Planning Application 22 Lancaster Grove

Planning Reference 2014/2037/P

I am instructed to comment upon the daylight, sunlight and overshadowing report provided by Syntegra Consulting in support of a planning application and dated April 2014. I regularly report to Camden, as the local planning authority, on daylight, sunlight and overshadowing and I attach herewith my credentials in confirmation of my expertise.

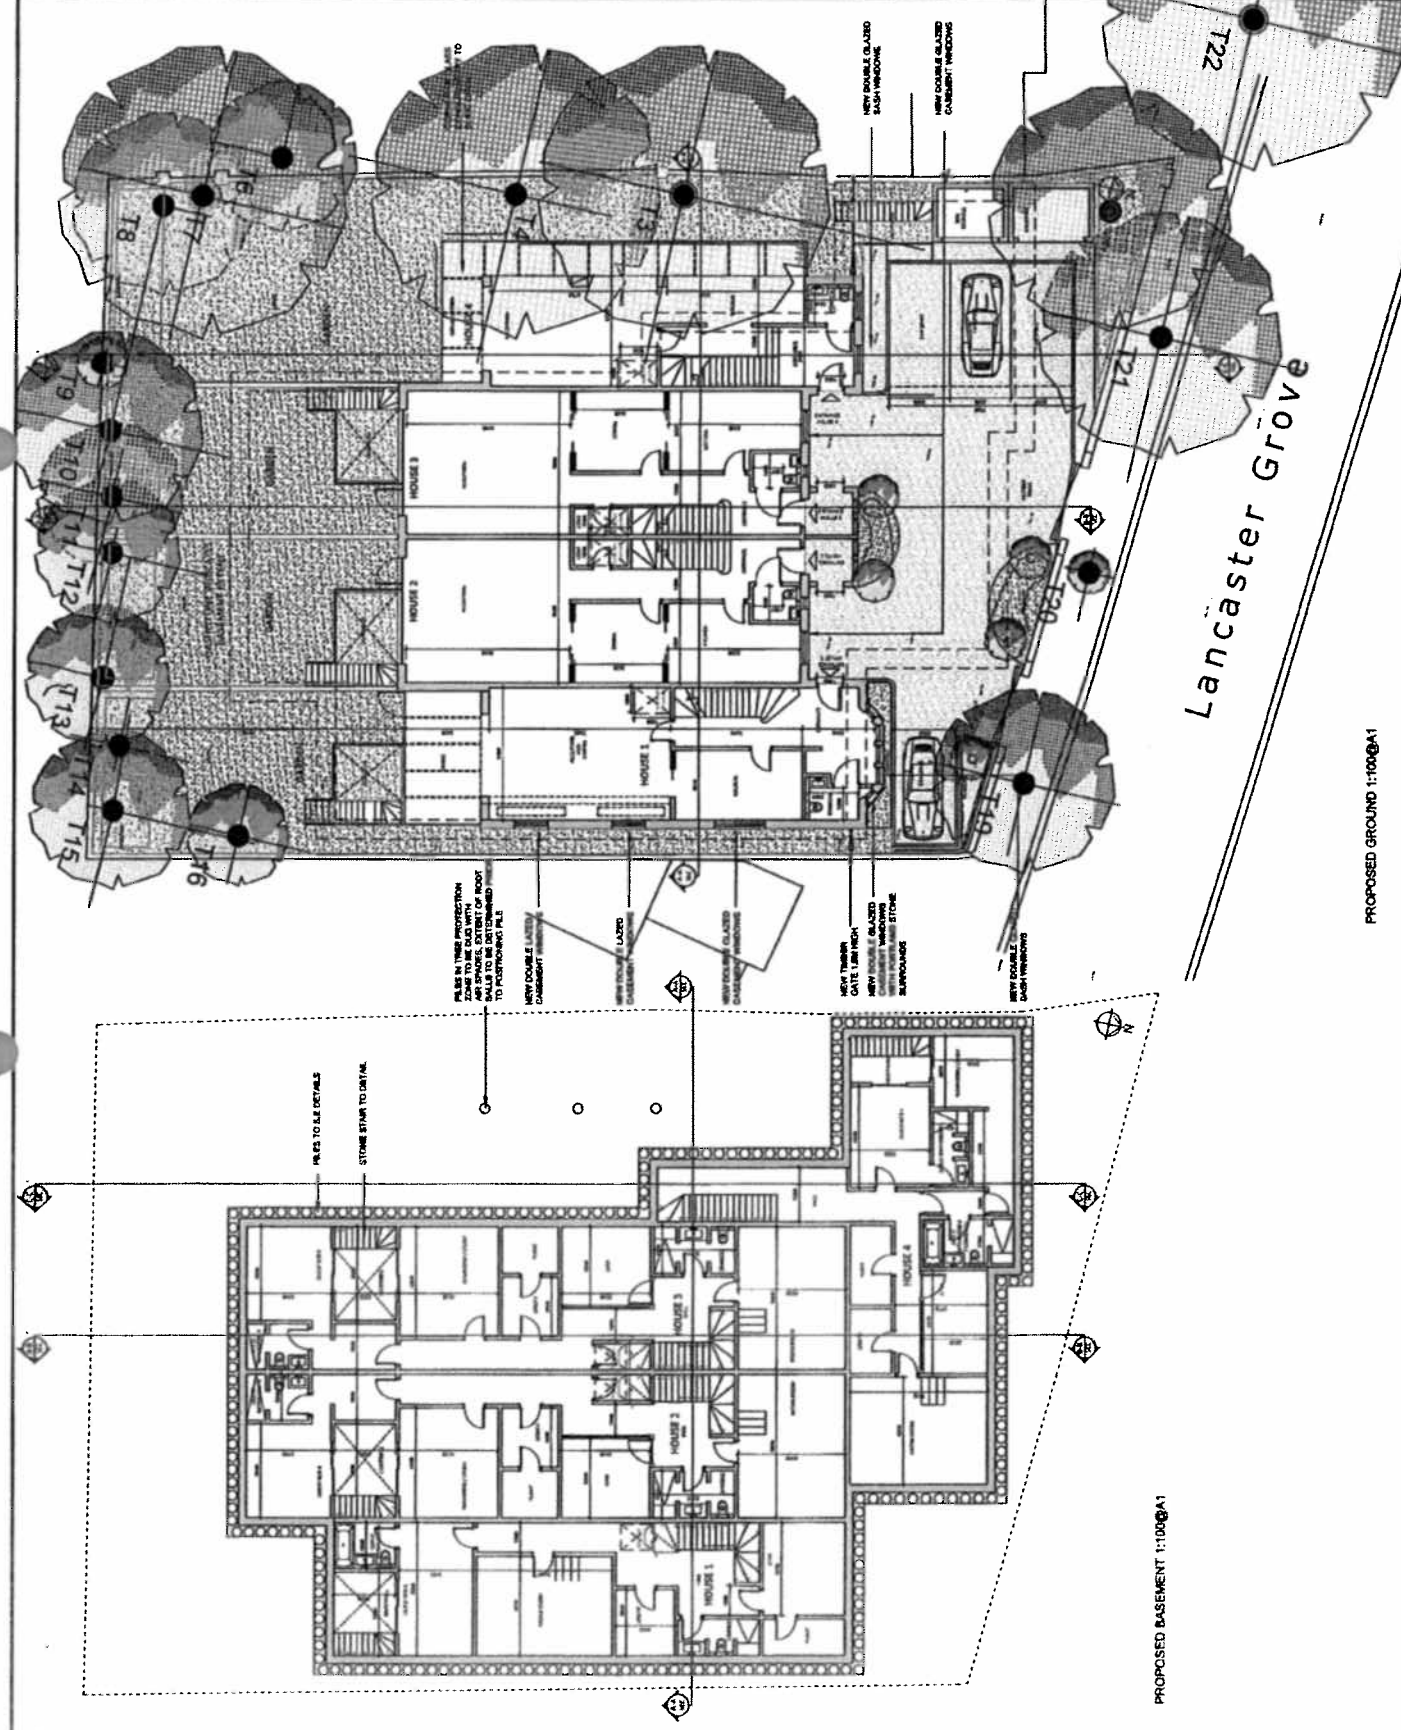
- (f) The model does not appear to reflect the proposed building. I draw your attention to the proposed site plan, drawing No. 22LG-P1-(10)-001.C. This defines a sideways 1m wide and a setback of similar scale, for the rear half of the house at first and second floor levels. The latter is not detailed on the model and the sideways is considerably more than 1m. This distorts all the readings and means they cannot be relied upon.

PROPOSED SECTION A-A
1:50 @ A1 1:100 @ A3

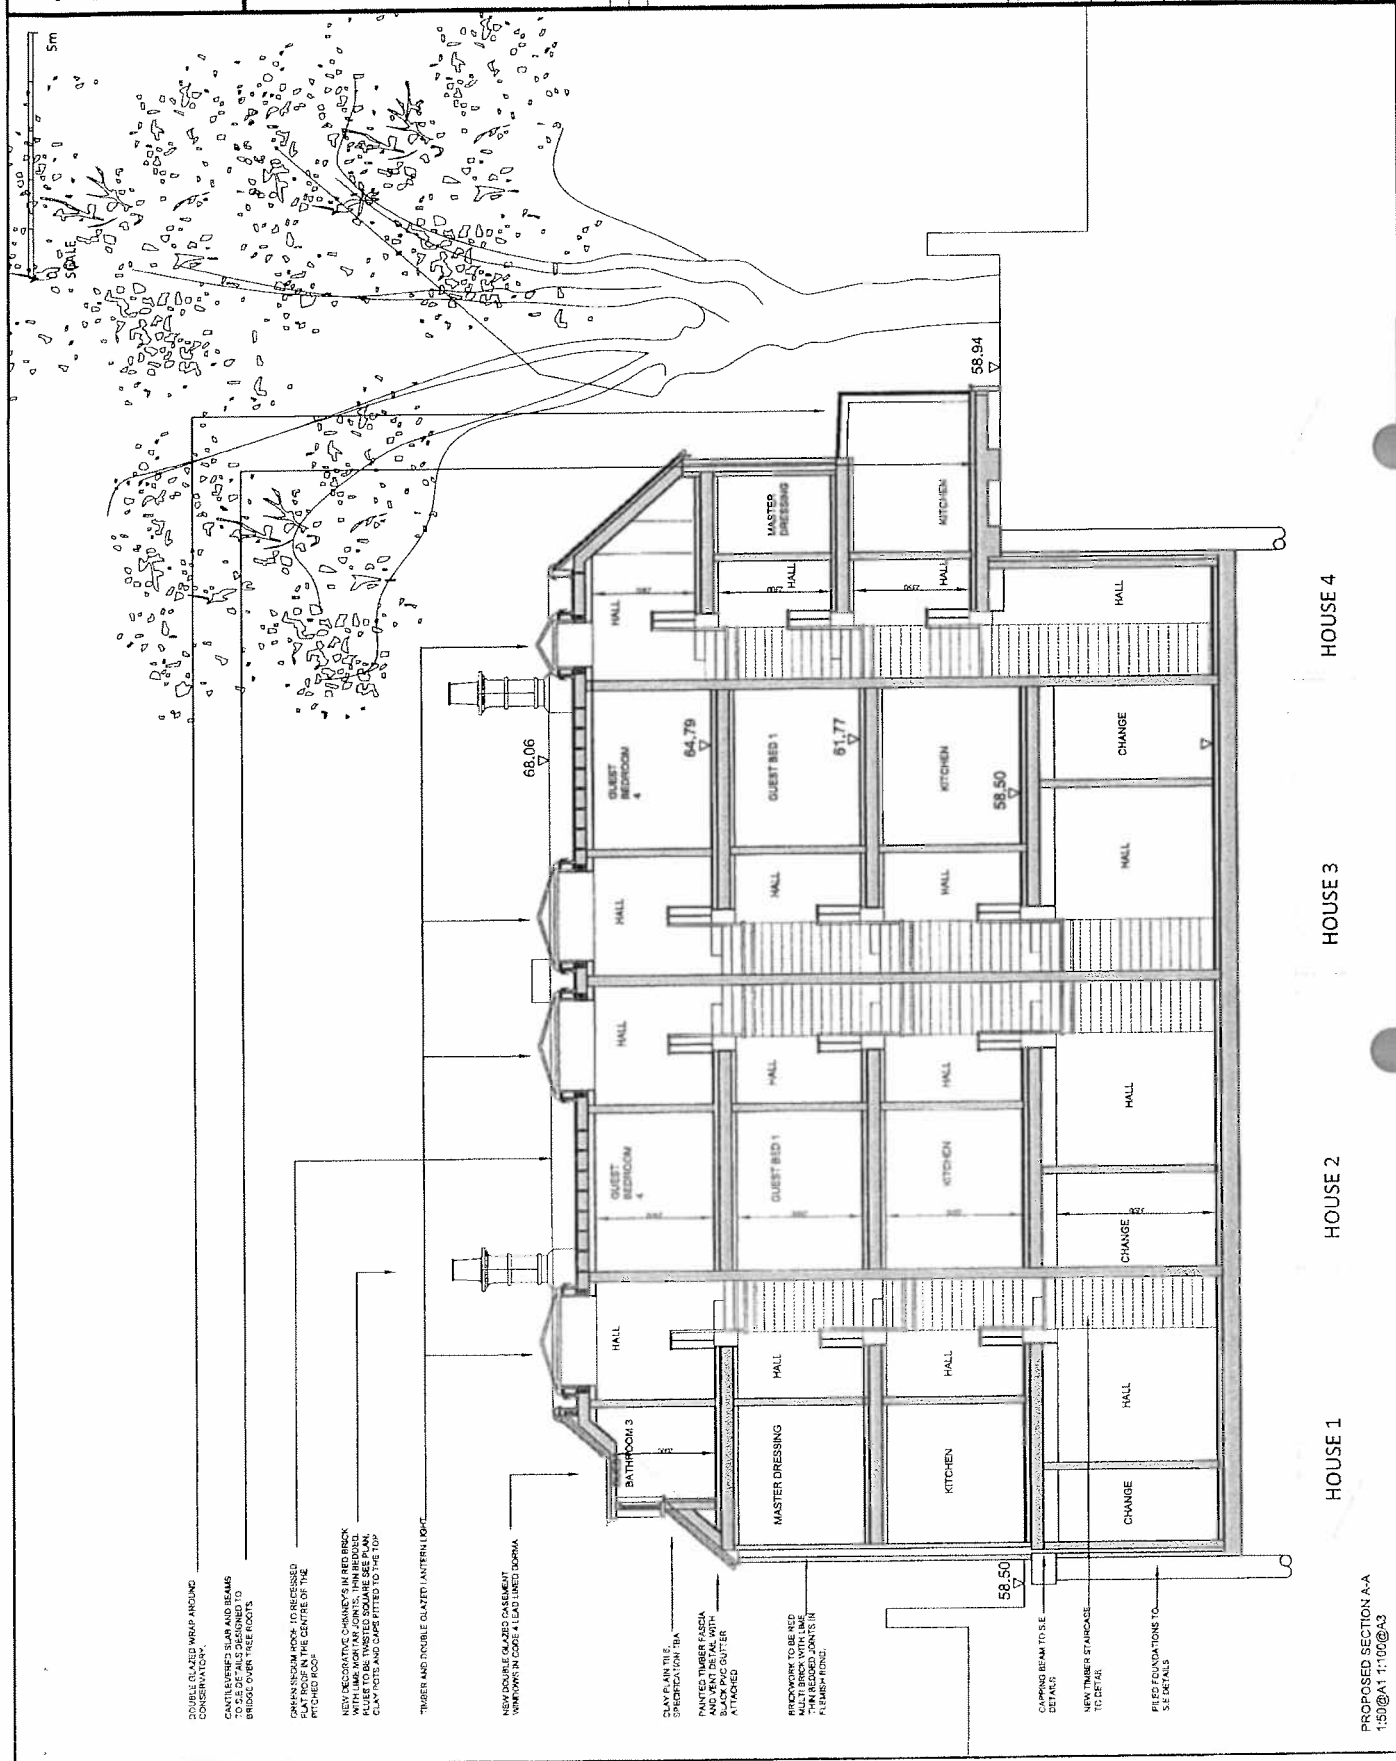
Continuing with the dining room windows. Even the revised graphics for the second window to this room show a window that is significantly larger than the window in situ and I attach a photograph to confirm this. See **Appendix 2**.
